## ADDENDUM NO. 1

Project Name: Landfill Segment 3 Cell 1

Bid Number: 2021006

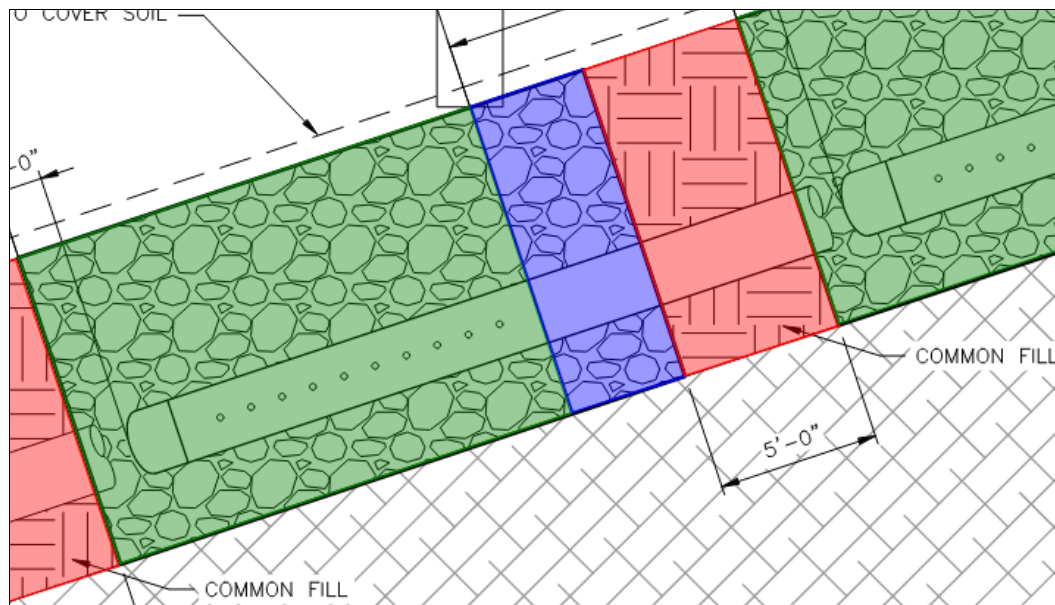
22. The three horizontal collector bid items (1.A.d.2, d.3, and d.4) have got me confused. Can you please provide a narrative explaining the three different scenarios & where each is on the drawing layout?

**The Bid Items referenced above are for the sideslope collectors. Refer to Section 250111, Paragraph 3.1, Subparagraphs E, F, and G for a unit price description of these Bid Items. An example of Bid Item 1A.d.2 (solid pipe and fittings in rock) is highlighted in blue color in the snapshot from Detail A on Sheet CD-3 below. An example of Bid Item 1A.d.3 (solid pipe and fittings in common fill) is highlighted in red color in the snapshot from Detail A on Sheet CD-3 below. An example of Bid Item 1A.d.4 (perforated pipe and fittings in rock) is highlighted in green color in the snapshot from Detail A on Sheet CD-3 below.**
